23 June 2017

WRL Ref: WRL2017018DJA L20170623

## **Hume Coal Project SSD 15\_7172: Peer Review of Conceptual and Numerical Modelling that Predicted Likely Groundwater Impacts**

**Figure 1: Model Calibration to Hydraulic Head Targets - Figure 4.2 of Appendix H, Volume 4B of the EIS (Coffey, 2016a)**

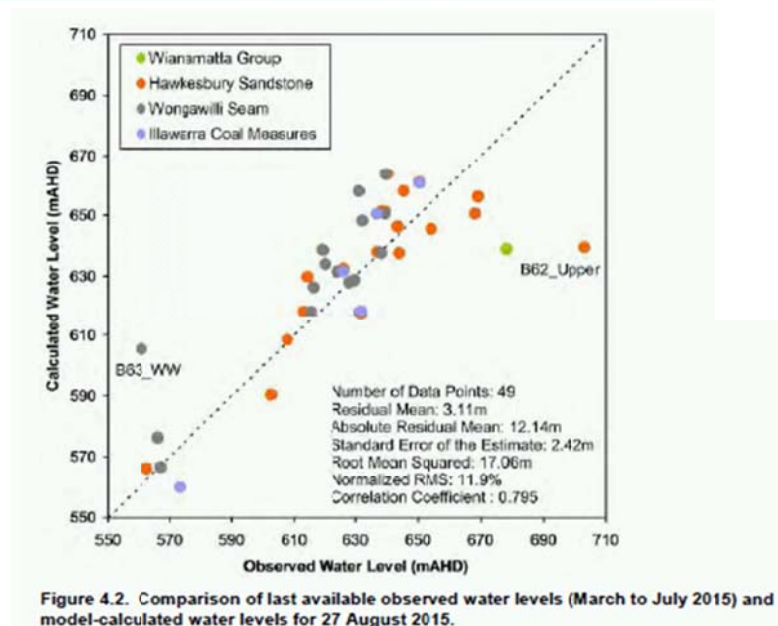
2. Normalised / Scaled root mean square errors (N/SRMS) for hydraulic head predictions and observations of about 12% (See Figure 1). This is larger than the 5% to 10% typically suggested in various guidelines. The EIS does not document any discussions with DPI Water or the Department of Planning regarding the acceptable calibration metrics for the model. DPI Water should be consulted and meeting minutes should be published. Similar plots for baseflows, hydraulic conductivity, specific yield and storage are not provided;

**Figure 2: Two Examples of Transient Calibration Performance - Figure B3 of Appendix H, Volume 4B of the EIS (Coffey, 2016a)**

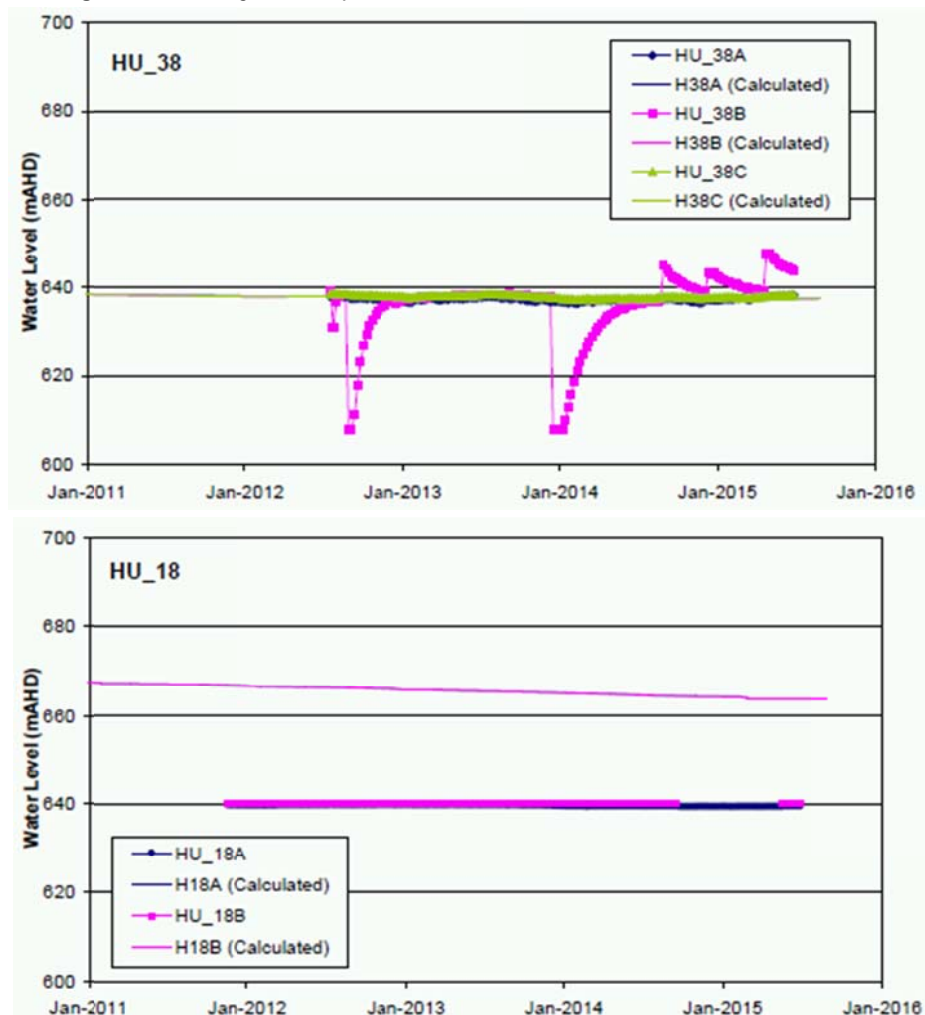
4. Most groundwater level hydrographs appear quiescent (Merrick, 2016), i.e. dormant, in response to stresses and all but one transient observation location (HU\_38) has large calibration errors (See Figures B3 in Appendix I, Volume 4B of the EIS). Note that HU\_38 is matched very precisely which is surprising for a manual calibration and may suggest that a manual calibration focussed on this well only or some unreported model optimisation was attempted for this one location. The reviewer also noted that HU\_38 appears to be located over the Hume Coal lease and not Berrima Mine area which is reported to be the focus of the calibration efforts to Berrima Mine inflows. Given that model properties were reported as constant across the model domain layers (Merrick, 2016), evidence needs to be provided to demonstrate that HU\_38 is a representative location to calibrate model parameters across the entire model domain. Based on figures in the EIS such as Figure C4 of Appendix H in Volume 4B of the EIS (Coffey, 2016b) it appears that HU\_38 is located in a sandstone outcrop area with below average hydraulic conductivity. Based on many of the transient calibration hydrographs, groundwater levels were predicted to decline by around 5m during calibration. This may point to the model initial condition being insufficiently developed in several parts of the model domain;

Figure 3: Figure C4 of Appendix H, Volume 4B of the EIS (Coffey, 2016a)

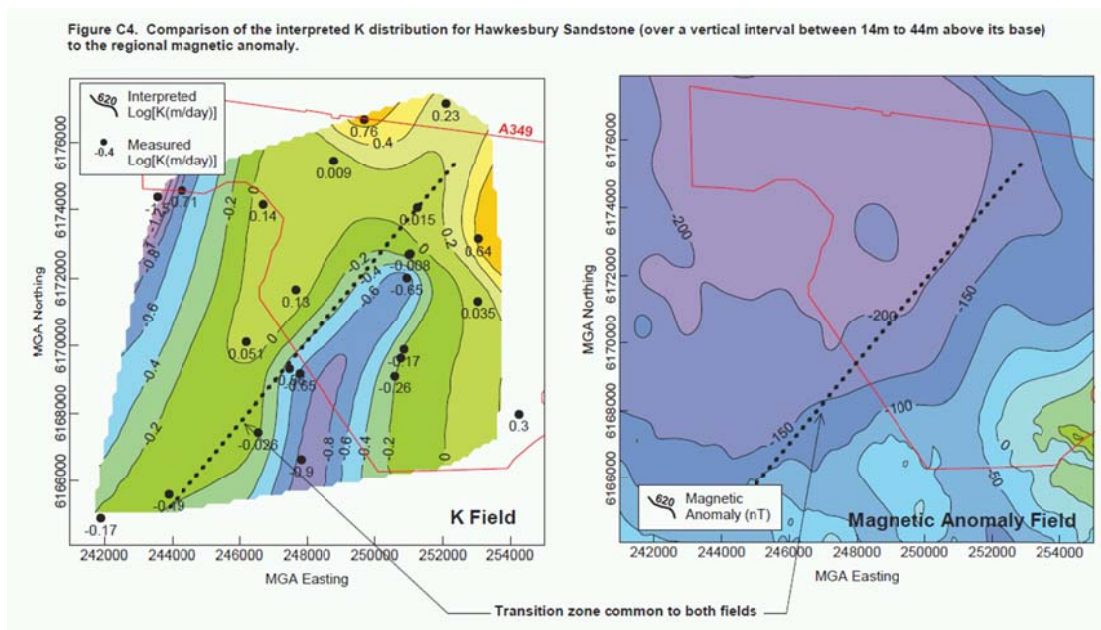
15. Hydraulic conductivity values in Hawkesbury Sandstone that are modelled by Coffey (2016b) as spatially invariable parameters (Merrick, 2016) despite clear and comprehensive mapping evidence by the proponent to the contrary as shown in Figure C4 of Coffey (2016a) – reproduced as Figure 3 above. In the reviewers opinion, a spatially variable distribution of

**Figure 6: Proponents mapping of low permeability interburden between Hawkesbury Sandstone and Coal Measures – Figure 4.3 of Appendix H, Volume 4B of the EIS (Coffey, 2016a)**

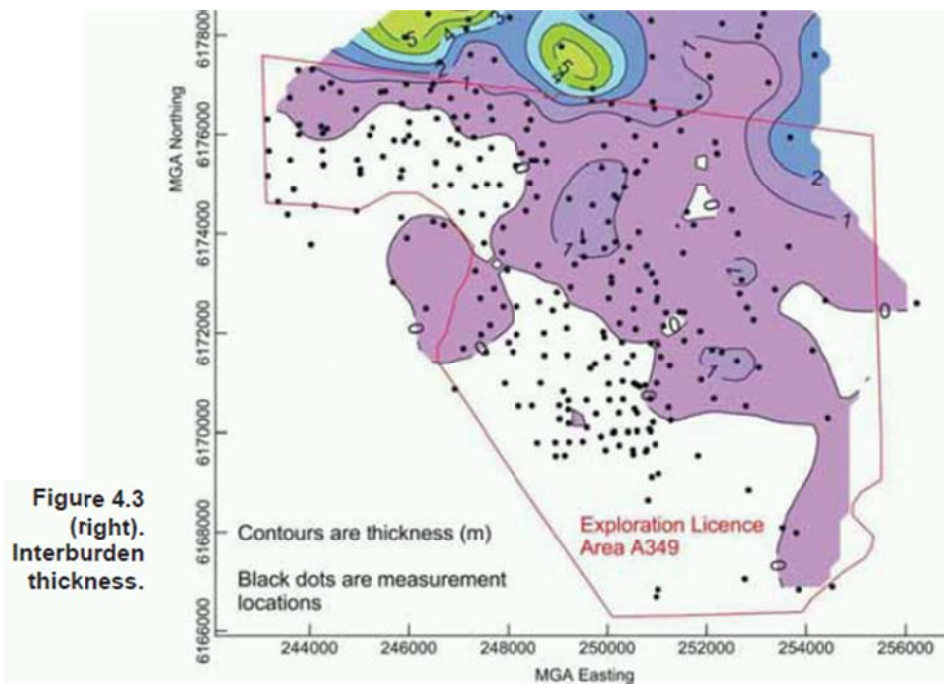
In the absence of detailing reporting of the thickness and properties of interburden between the coal seam and the productive Hakwesbury Sandstone aquifer for each of the proposed mine panels, in the reviewer's opinion an average drain conductance parameter of about 1.0 m<sup>2</sup>/day would be more consistent with the data presented to date with values varying spatially between 0.05 m<sup>2</sup>/day and 20 m<sup>2</sup>/day depending on the local geological logging, mapping and facies transmissivity data. In the reviewer's opinion the model should be recalibrated with a spatially variable parameter set. A more suitable sensitivity / uncertainty analysis for this parameter should be provided.

**Figure 7: Proponent's calibration to Berrima Mine Outflows for one-two year stress periods – Figure 6.1 of Appendix I, Volume 4B of the EIS (Coffey, 2016a)**

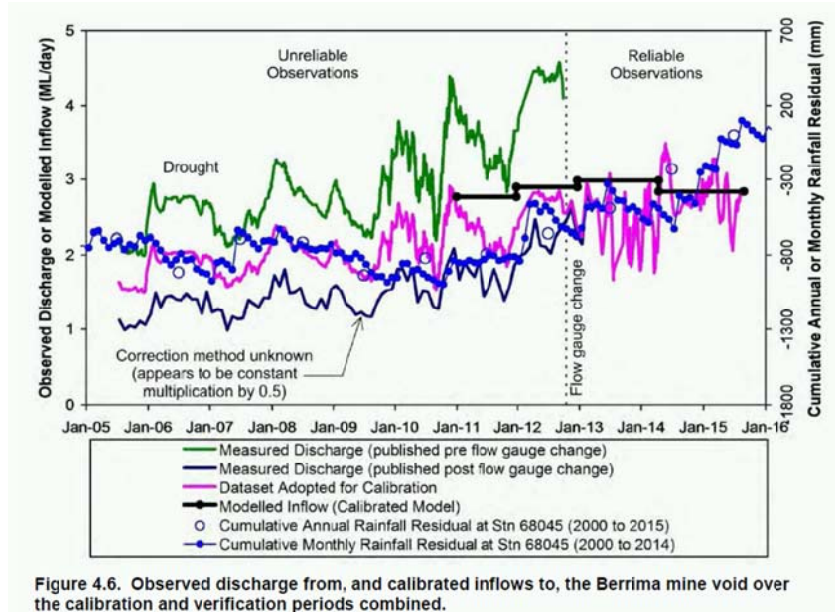
13. Application of a linear drift correction of minus 30% to 41% to recorded outflows from Berrima Mine between mid-2009 and October 2012 to achieve calibration to predicted Berrima Mine inflows. Noting that the rating curves for any weir might only be accurate to  $\pm 5\%$  to  $20\%$ , the proponent should present an analysis of error for the flow gauging weirs used at Berrima Mine, justify the physical basis for the time dependent drift in the rating curve and report the sensitivity of the model calibration and prediction to uncertainty regarding mine inflows and outflows, including volumes of water that may leak into the workings, only to flow back into the formation;

14. The green line showing measured discharge from Berrima mine in Figure 4.6 of Coffey (2016b) does not match the raw data submitted in EPL returns for Berrima mine. The proponent should report the duration and details of the moving average filter that has been applied to the green line shown in Figure 7 above.

**Figure 9: Figure 2.8 of Pells and Pan (2017) – Comparison of EIS modelled specific storage values reported in Coffey (2016b) to typical values of rock bulk modulus and porosity**

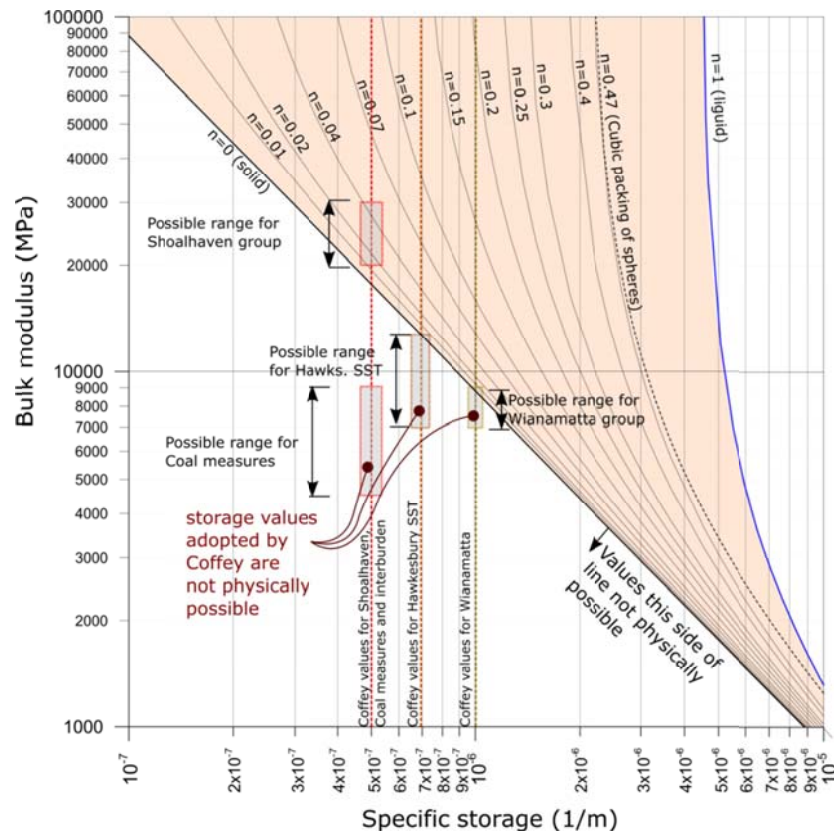
Confined aquifer water storage values (specific storage) in Hawkesbury Sandstone that are one order of magnitude lower than the best field measurements presented by the proponent and inconsistent with mathematical equations applied to typical rock porosity and compressibility data for the Sydney Basin (Pells and Pan, 2017).

Figure 10: Coffey (2016b) Model Parameters as Summarised by Pells and Pan (2017)

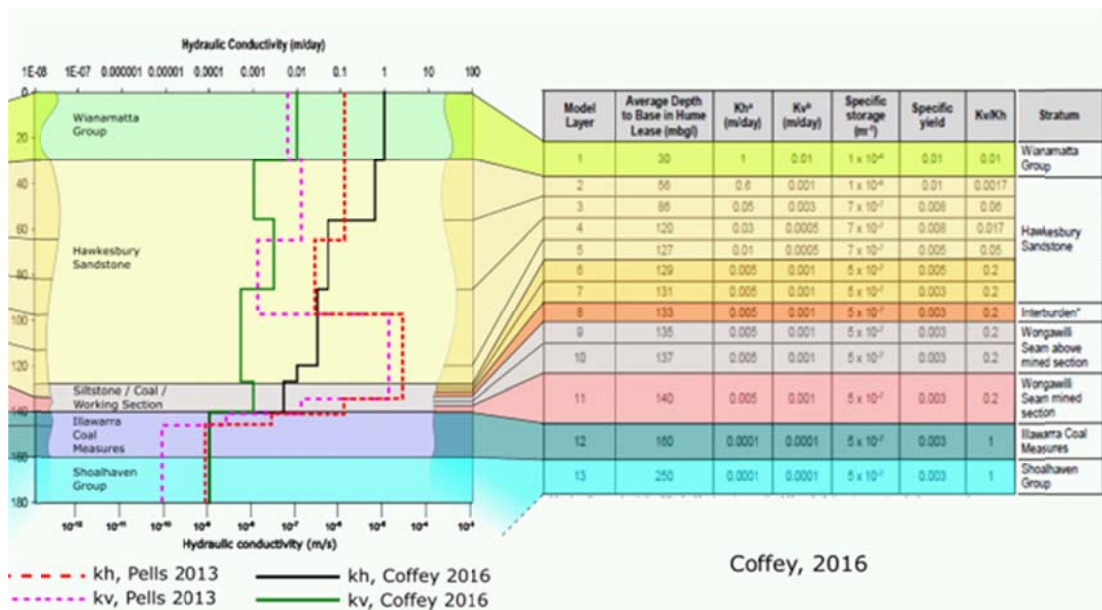
- vi. Measurements of coal seam permeability to demonstrate that the modelled coal seam properties are a good representation of the site conditions.
23. Hydraulic conductivity values in the overlying Hawkesbury Sandstone at two (2) to two hundred (200) times lower than best available field measurements in the public domain and about ten (10) times lower than what was modelled by Boral at the nearby Berrima Mine and quite different to those values modelled by Pells and Pan (2017):

Figure 11: Coffey (2016b) and Pells and Pan (2017) Model Parameters vs Site Data (reproduced from Pells and Pan, 2017)

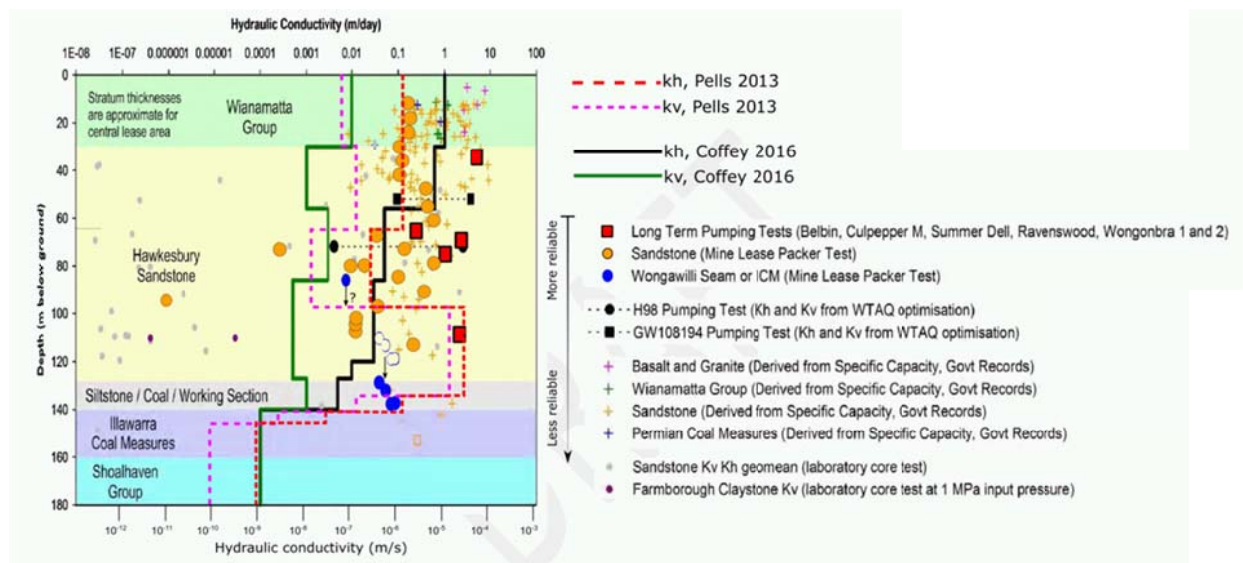
- i. Horizontal hydraulic conductivity (Kh) values consistent with “long duration pumping tests” reported for distant sites in Tammetta (2012) but apparently inconsistent with analysis for local pumping wells in the model domain including H98, GW108194, Belbin, Culpepper M, Summer Dell, Ravenswood and Wongonbra 1 and 2 which yielded much higher K values (see figure below);

Figure 14: Figure C3 from Vol 4B, App H, App C of the EIS

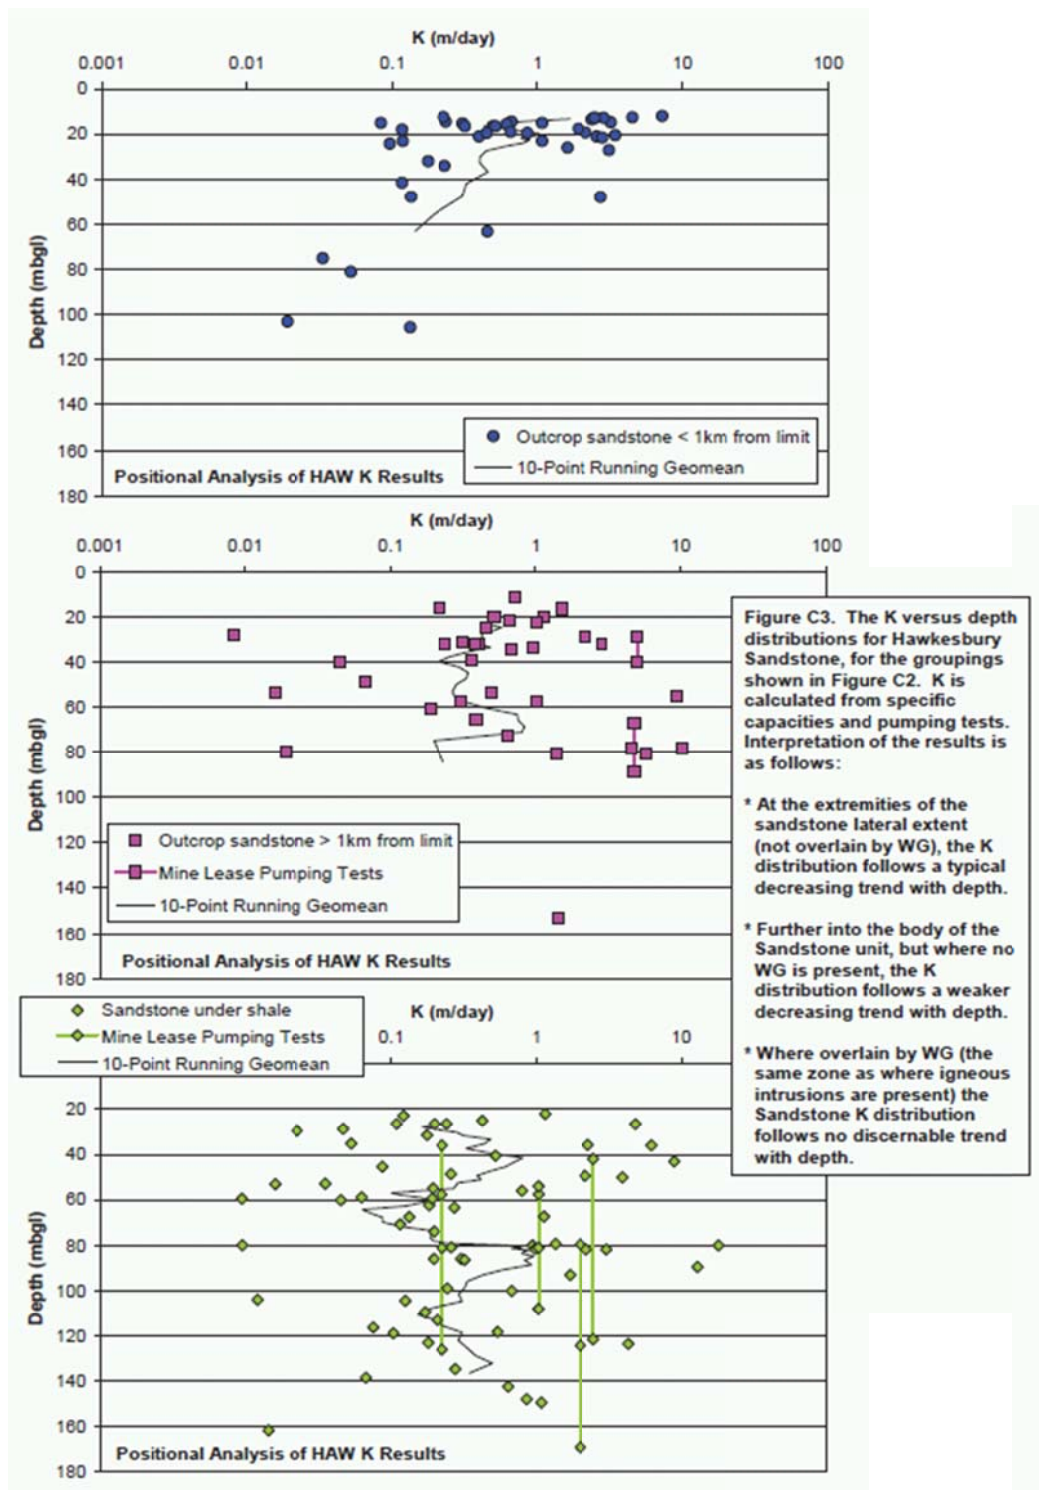
- iii. Hydraulic conductivity is modelled to decrease significantly with depth which is inconsistent with the site data as presented in Figure C3 of Appendix H, Volume 4B of the EIS (compare Figure 10 and 14). It is acknowledged that some decreasing trend is likely and could be inferred in the upper panel of Figure 14 for outcrop sandstone, however, it must also be acknowledged that there are insufficient data below 40m depth to infer any statistically significant conclusions about the nature of the trend.

Calibration and uncertainty analysis should be reattempted with spatially variable values of hydraulic conductivity and larger values of storage and recharge as the data dictates. The model should be recalibrated with calibration optimisation software that minimises an objective function of residuals calculated as the difference between observed and modelled aquifer hydraulic properties, groundwater levels and flows. Each of these residual groups should be weighted based on worth and each data point weighted based on data-point reliability. Identifiability and sensitivity of all parameters should be reported;

Figure 15: Figure 5.7 from Vol 4B, App H of the EIS

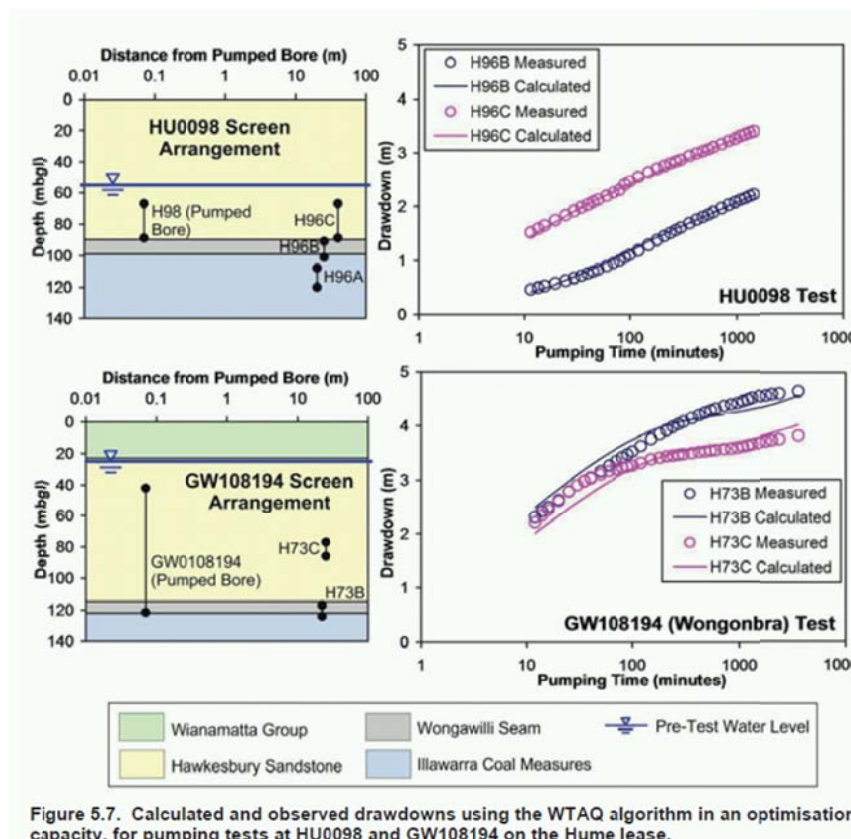
25. It appears that an unconfined aquifer model was utilised to interpret the aquifer test data, yet there appears to be some suggestion of very low permeability layers in the Hawkesbury sandstone with inferred Kv values that are two to four orders of magnitude lower than the inferred Kh values. The proponent should discuss whether parts of the aquifer system are confined or unconfined. If parts of the aquifer are actually confined, then the proponent should describe how an unconfined aquifer analysis might impact the aquifer test interpretations of aquifer properties. If this effect is uncertain, the aquifer test data should be reinterpreted with a geological model and set of assumptions that match the available field data. Given that the numerical model does not appear to rely on the aquifer test interpretations at the site, it is also recommended that the proponent demonstrates how well their numerical model parameters reproduce the available pumping test data. This work may require some refinement to the model (or development of a sub-model) as most of the pumping and observation wells appear to be located in the same numerical model grid cell.

**Figure 16: Comparison of STRM and LIDAR cross sections – Figure 4.3 Appendix I, Volume 4B**

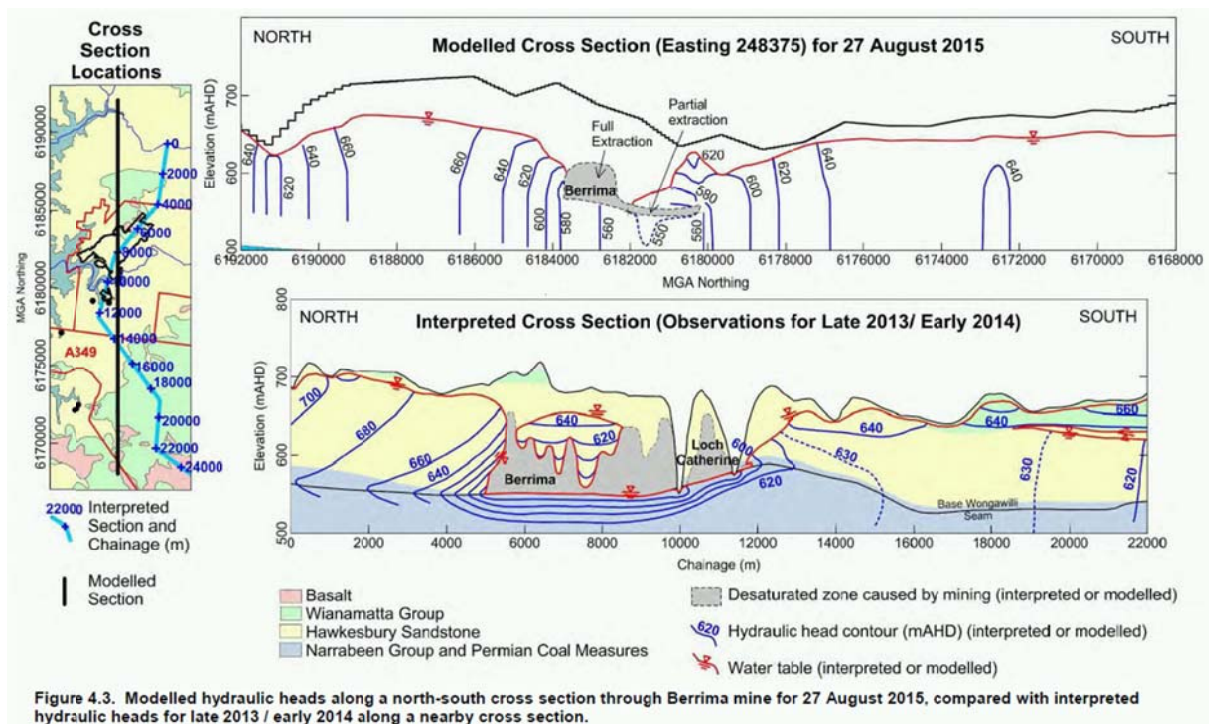
33. The EIS does not report or show how the geology is defined around the river channels and the Merrick (2016) review suggests some river drain conductance values seemed to be set too high. Merrick (2016) and Coffey (2016b) suggests this would be conservative as stream base flow impacts would be over-predicted. The present reviewer cannot agree with this conclusion as insufficient information on model construction has been reported and several lines of evidence in the model reporting point to potentially different conclusions. To demonstrate that the river drain conductance parameter is appropriate and conservative, the modellers should detail how the surfaces in the model were created, present these surfaces in plan-view and in cross-section view through several of the creeks and streams, particularly the most incised ones, showing model layers and hydraulic conductivity.

In support of this recommendation it is noted that a common problem in many simple numerical models is the creation of model layers by subtracting surfaces of sparse data from the Digital Elevation Model (DEM). If this DEM has large errors (like STRM data) and/or the geological picks and properties describing these computed geological surfaces are not modified then low permeability layers of variable thickness may be “wrapped around” the streams resulting in incorrect predictions of groundwater and surface water exchange. Figure 17 (next page) shows what this might look like for the proponent’s groundwater model based upon the average model layer elevations reported by the proponent.
